Responses-to-Comments (“R-to-C”) Table dated 21.2.2024

Proposed Rezoning from “Government, Institution or Community” to “Residential (Group B)6” Zone to Include Social Welfare Facility (RCHE and DE only) and Public Vehicle Park (excluding container vehicle) at Lots Nos. 148 S.A RP (Part), 148 S.B RP (Part), 149 RP, 150 S.A, 150 S.B and 151 in D.D. 206 and Adjoining Government Land, West of Wu Kai Sha Road, Ma On Shan, New Territories

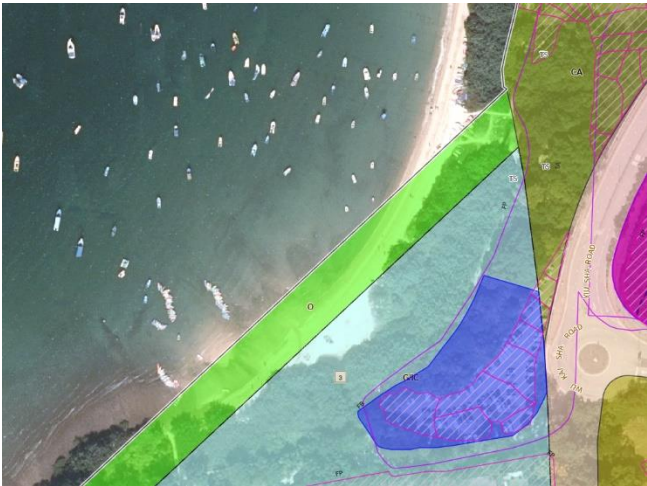
2.	The proposed development is in close vicinity of the "CA" zone, which covers a mature coastal woodland and is of ecological value, and adjacent to an intertidal habitat with some mangrove species. The applicant should include in the submission an assessment on whether the proposed development would induce adverse ecological impacts to the surroundings and propose appropriate precautionary and mitigation measures, if necessary.

<p>It should be noted that in future, more than half of Wu Kai Sha Beach will be taken away to make way for a planned 20m wide waterfront promenade, presently zoned as “O” on the OZP, as shown on the diagram below.</p>
